Visual Impact from nearby residences.

Trustpower and their consultant Green Bean Design were asked to assess the Visual Impact of the revised Rye Park wind farm on non-associated residences within 3 kilometres of a turbine.

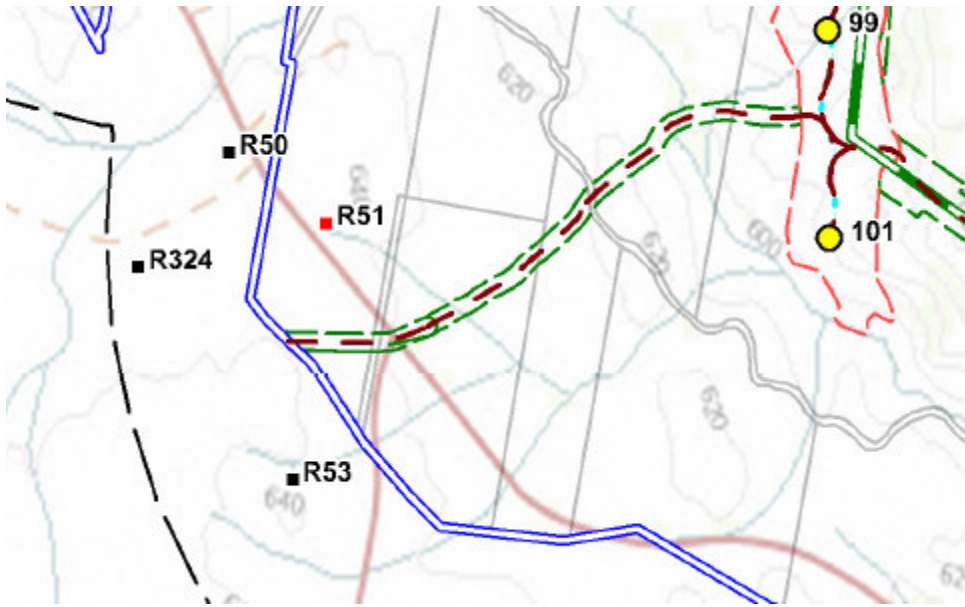
To try and work out the difference takes time and effort. For instance, the photomontage for R324:

Is the photo taken from the residence? No, it is taken at the entrance to the property 160 metres away from the residence.

Is the residence in the photo R324? No it is R50.

Which turbines are in the photomontage? Who knows, without significant extra work.

Is the panoramic photo centred at the nearest turbine? No, the nearest turbine (101) is at the extreme right, behind the tree, if it makes it into the photomontage at all.

All wind farm landscape architects should know by now not to have foreground vertical objects in their photomontages. GBD could have walked to the other side of the tree and taken the photographs. This is one of many similar examples. For this and other reasons, the whole of the photomontage section of the LVIA is therefore highlighted in the “Neither false nor misleading section” of this submission
